# Product Change Notice

(PCN Tracking Number: EE-QR-220409-20)

<b>Customer:</b>	All Customers						
<b>Renesas Product Type:</b>	RH850/F1, R1, E1 and C1 series, refer to <a href="#">Product List</a>						
<b>Description of Change:</b>	Addition of wafer type for Naka products						
	<table border="1" style="width: 100%; border-collapse: collapse;"> <thead> <tr> <th style="background-color: #4F81BD; color: white;">Wafer Process</th> <th style="background-color: #4F81BD; color: white;">Current wafer specifications</th> <th style="background-color: #4F81BD; color: white;">Wafer specifications after change</th> </tr> </thead> <tbody> <tr> <td style="text-align: center;">Naka</td> <td style="text-align: center;">EPI Wafer</td> <td style="text-align: center;">EPI Wafer Non-EPI Wafer</td> </tr> </tbody> </table>	Wafer Process	Current wafer specifications	Wafer specifications after change	Naka	EPI Wafer	EPI Wafer Non-EPI Wafer
Wafer Process	Current wafer specifications	Wafer specifications after change					
Naka	EPI Wafer	EPI Wafer Non-EPI Wafer					
<b>Reason for Change:</b>	In order to realize stable supply, Renesas will implement specification addition of non-EPI wafers for Naka produc

Example of electrical distribution at +25°C

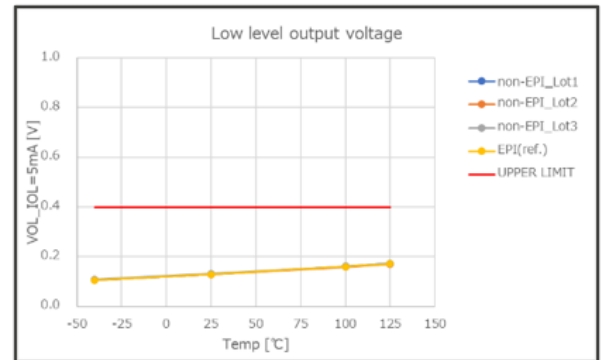
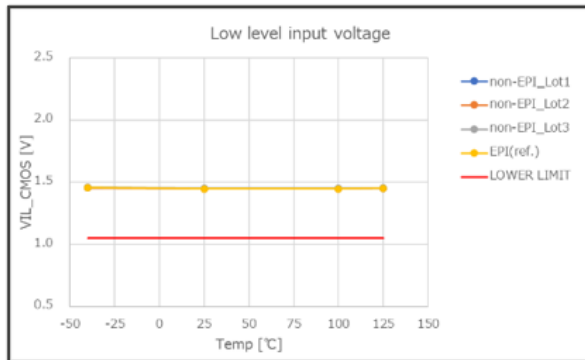
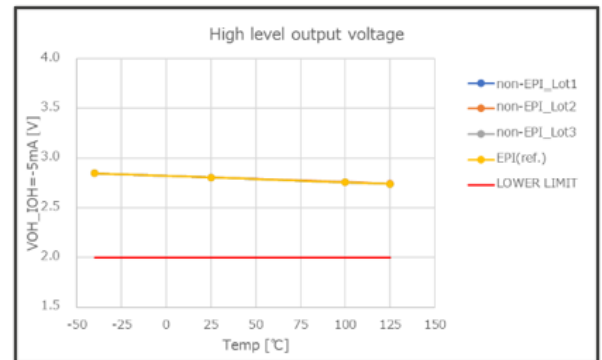
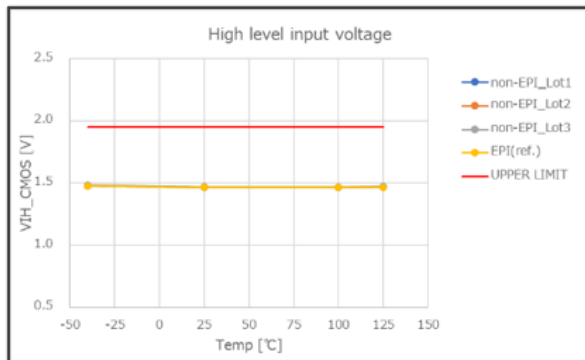
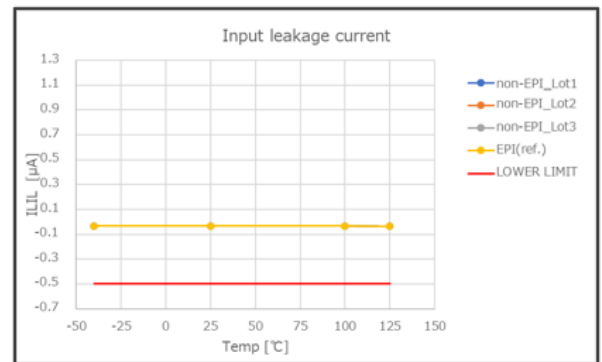
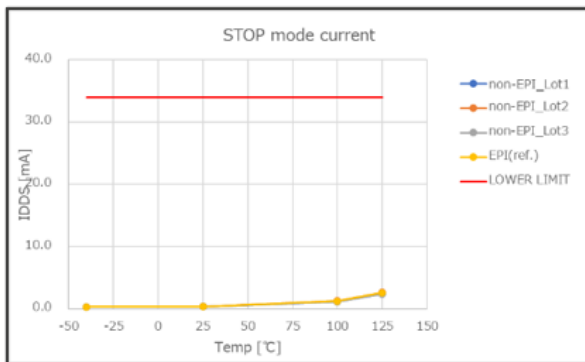
We confirmed the electrical distribution results at 4 temperatures (-40°C, +25°C, +105°C, +125°C) and confirmed no significant difference between non-EPI and EPI products. Cpk for all parameters is > 1.67.

We confirmed that there was no significant difference in electrical characteristics between EPI and non-EPI products.
